PEST CONTROL EXPERTS

Facility Name & Address: Garudapolyflex Foods Pvt Ltd , Electronic City, Bangalore	Audited On: 30-11-2023
Audited By: SURESH KUMAR.V	
Client Contact Person Name: Mr. Saravan (QC)	PC Experts Contact Person Name: SURESH KUMAR.V
Client Contact Person No: 8973047541	PC Experts Contact Person No: 9087200011

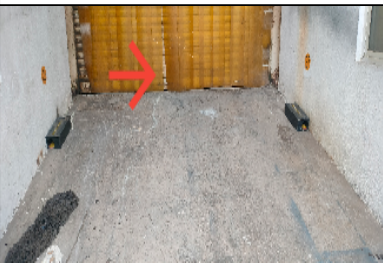
4		Location	R&D area		
		Cleaning / sanitation & Housekeeping Issues	Nil		
		Structural Issue (Pest harbourages)	Gap observed between the finishing metal Area		
		Access Issues	Nil		
		Description of Pest Infestation	It is Serious Threat for Ants, lizard		
		Any other observations	Nil		
		Preventive Action suggested to customer	Gap should be closed with rubber breading or silicone sealant		
		Curative action from	We are instructed to Technician for Regular Monitoring.
